TRANS/WP.29/932  
23 July 2003

World Forum for Harmonization of Vehicle Regulations (WP.29)

DRAFT SUPPLEMENT 15 TO THE 04 SERIES  
OF AMENDMENTS TO REGULATION No. 16

(Safety-belts)

Figure 1 – ISO/F3 envelope dimensions for a full-height forward-facing toddler CRS (height 720 mm) - ISOFIX SIZE CLASS A

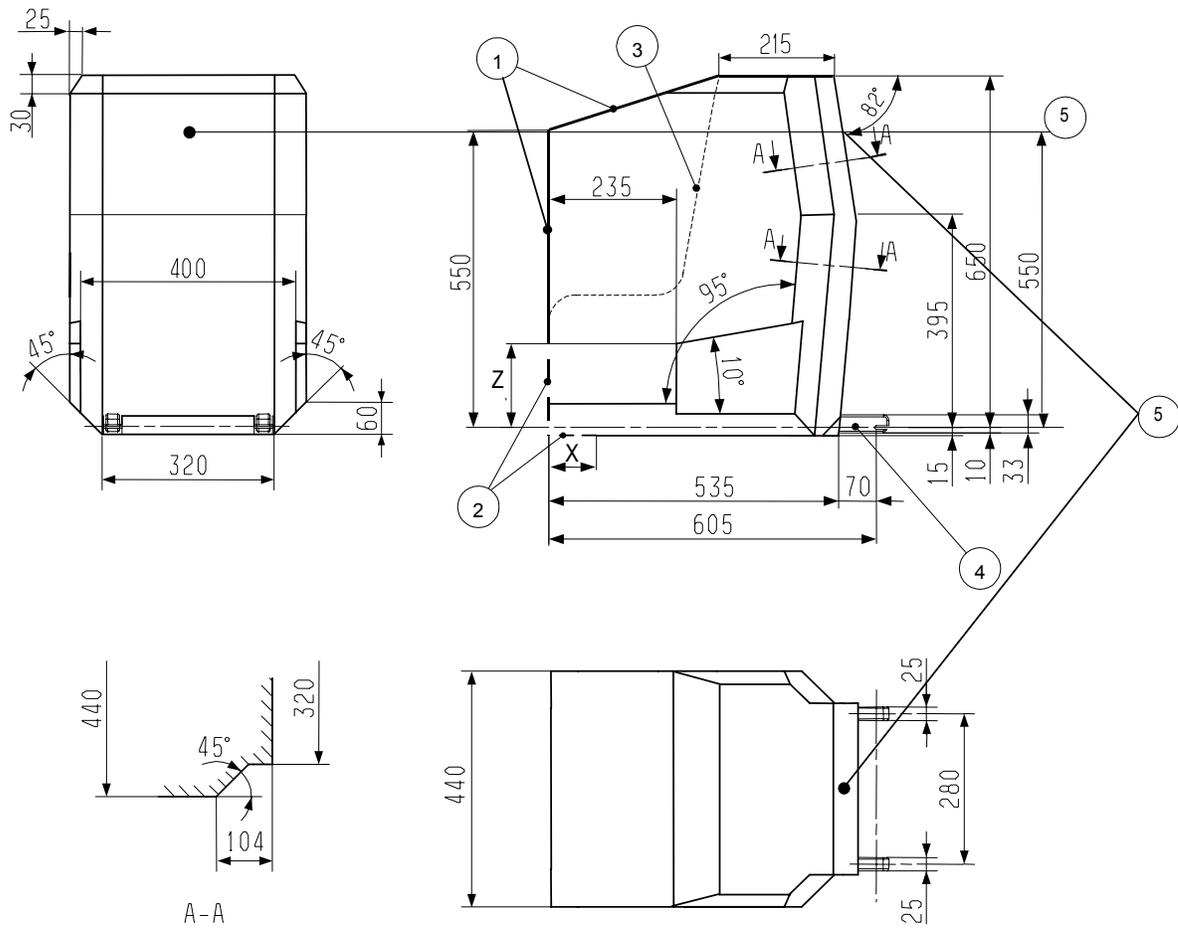
4.1. Full-height forward-facing toddler child restraint systems envelope.

- 1 Limits in the forward and upwards directions
- 2 Dashed line marks area where a support leg, or similar, is allowed to protrude
- 3 N/A
- 4 Further specifications of the connector area is given in R44

Figure 2 – ISO/F2 envelope dimensions for a reduced-height forward-facing toddler CRS, (height 650 mm) – ISOFIX SIZE CLASS B

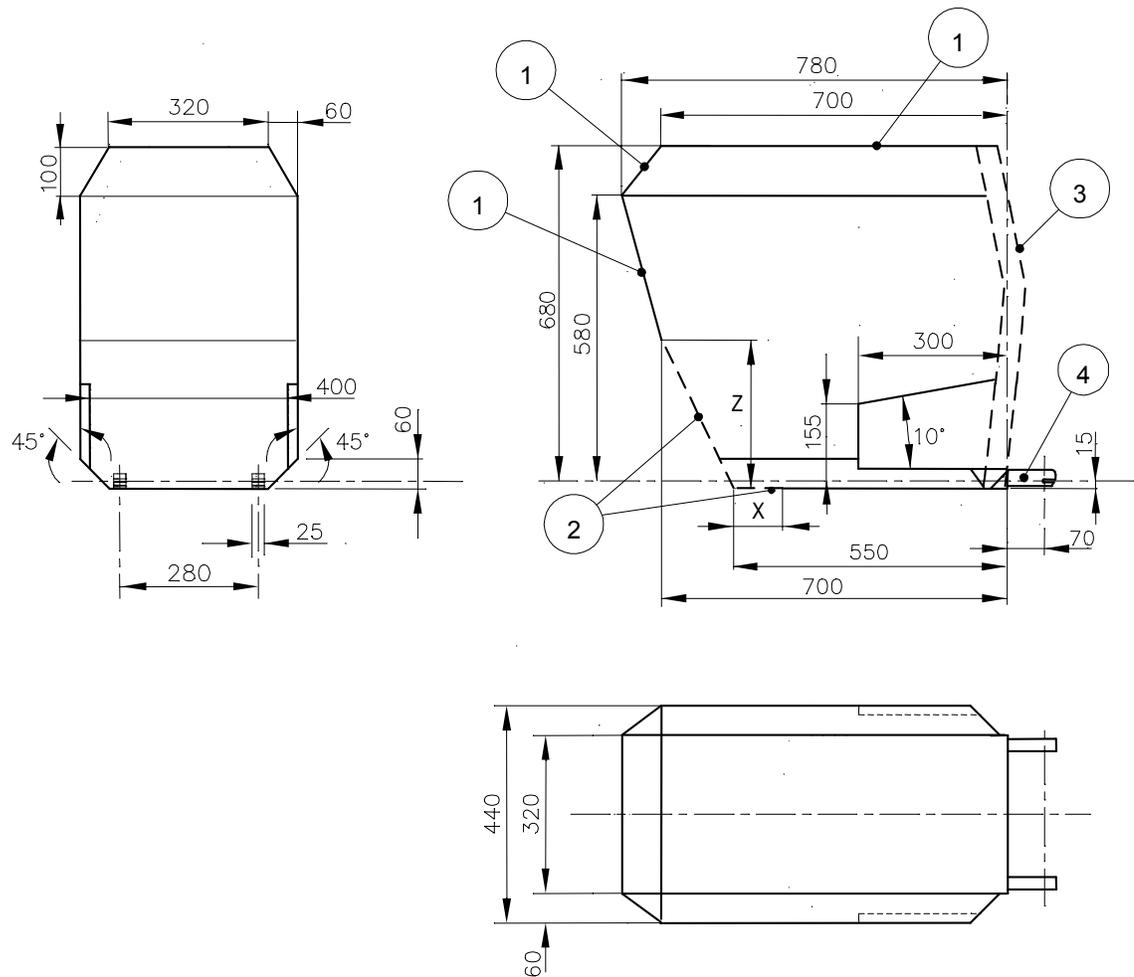
4.2. Reduced-height forward-facing toddler child restraint systems envelope.

- 1 Limits in the forward and upwards directions
- 2 Dashed line marks area where a support leg, or similar, is allowed to protrude
- 3 Shape of CRF for positioning purpose in R14
- 4 Further specifications of the connector area is given in R44
- 5 ISOFIX top tether attachment

Figure 3 – ISO/R3 envelope dimensions for a full-size rearward-facing toddler CRS – ISOFIX SIZE CLASS C

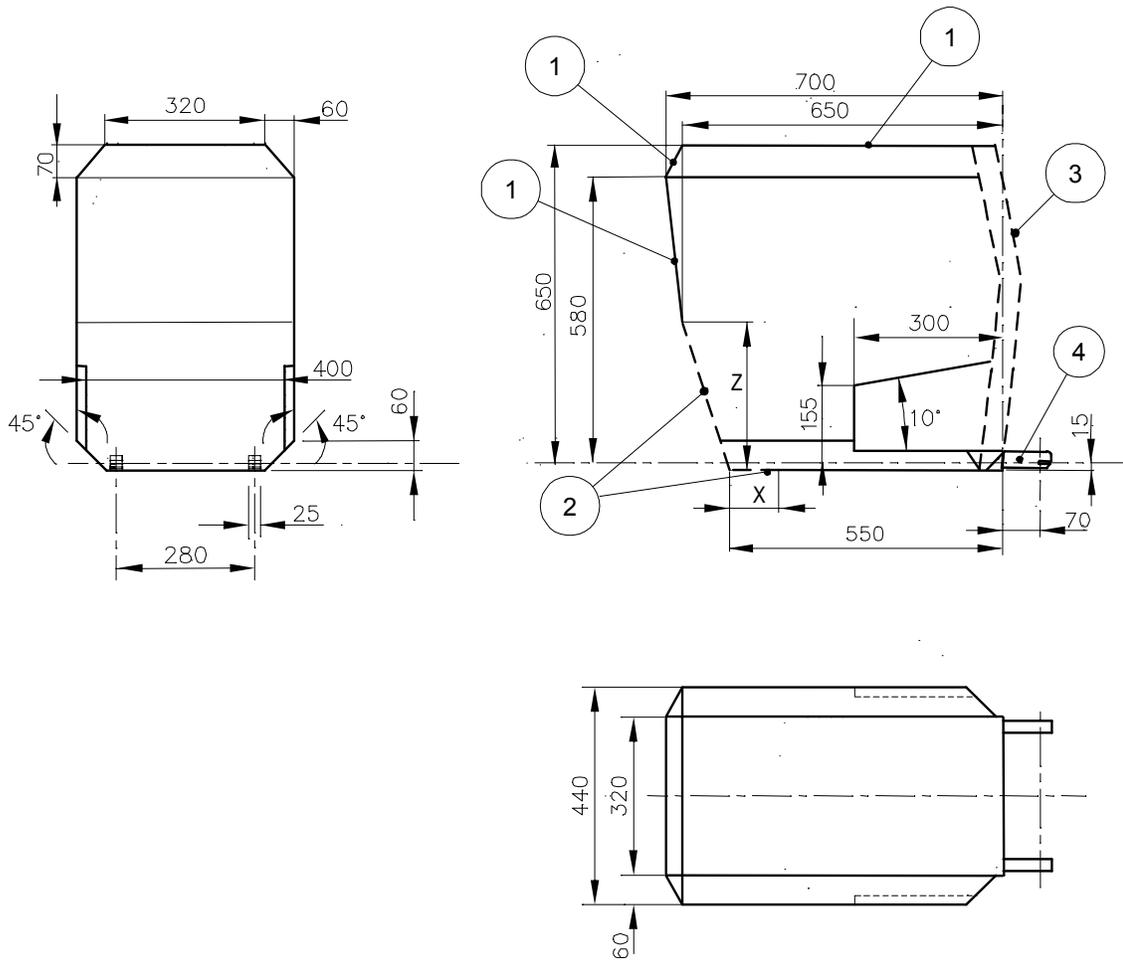
4.3. Full-size rearward facing toddler child restraint systems envelope

- 1 Limits in the rearward and upwards directions
- 2 Dashed line marks area where a support leg, or similar, is allowed to protrude
- 3 The backwards limitation (to the right in the figure) is given by the forward-facing envelope in Figure 2
- 4 Further specifications of the connector area is given in R44

Figure 4 – ISO/R2 envelope dimensions for a reduced-size rearward-facing toddler CRS – ISOFIX SIZE CLASS D

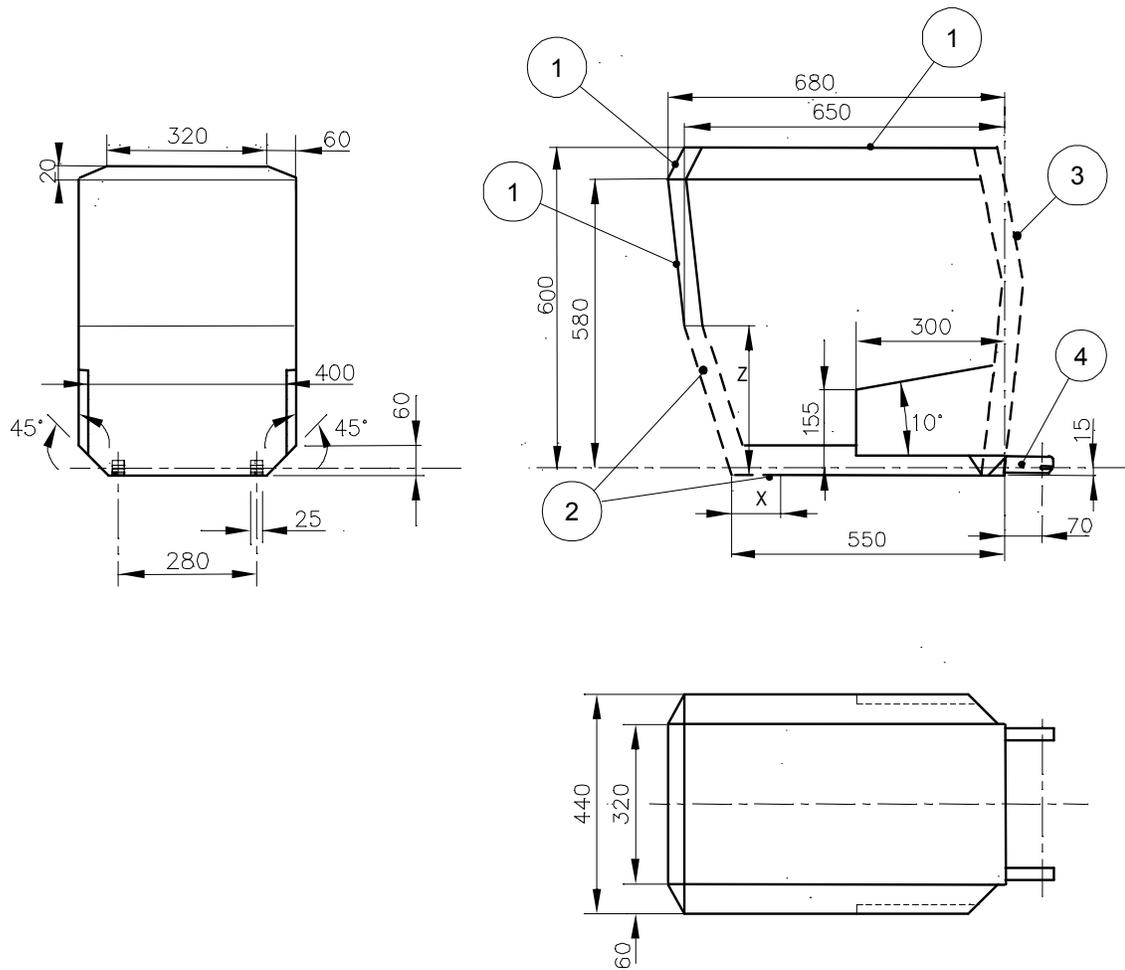
4.4. Reduced-size rearward-facing toddler child restraint systems envelope

- 1 Limits in the rearward and upwards directions
- 2 Dashed line marks area where a support leg, or similar, is allowed to protrude
- 3 The backwards limitation (to the right in the figure) is given by the forward-facing envelope in Figure 2
- 4 Further specifications of the connector area is given in R44

Figure 5 – ISO/R1 envelope dimensions for an infant-size rearward-facing CRS – ISOFIX SIZE CLASS E

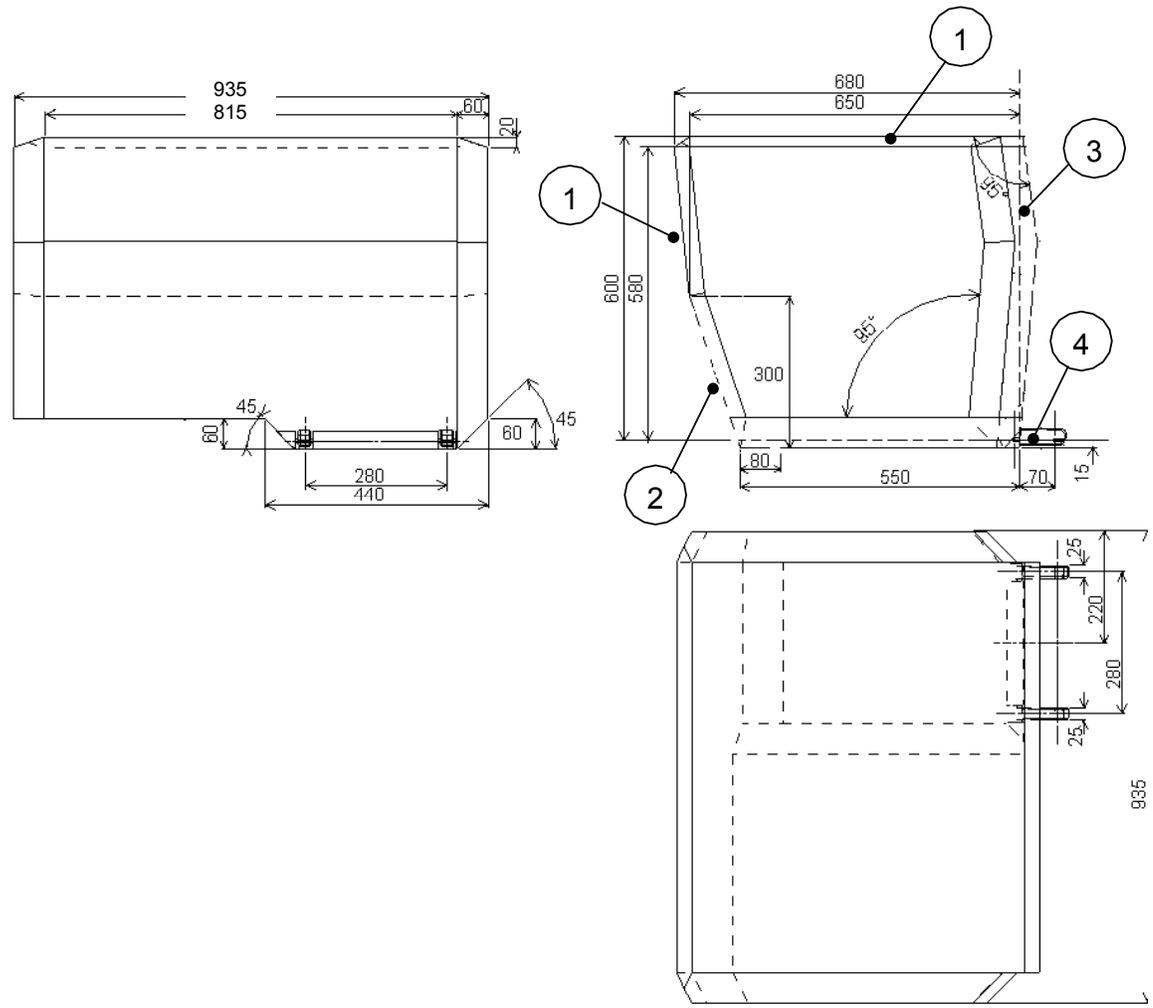
4.5. Rearward-facing infant child restraint systems envelope

- 1 Limits in the rearward and upward directions
- 2 Dashed line marks area where a support leg, or similar, is allowed to protrude
- 3 The backwards limitation (to the right in the figure) is given by the forward-facing envelope in Figure 2
- 4 Further specifications of the connector area is given in R44
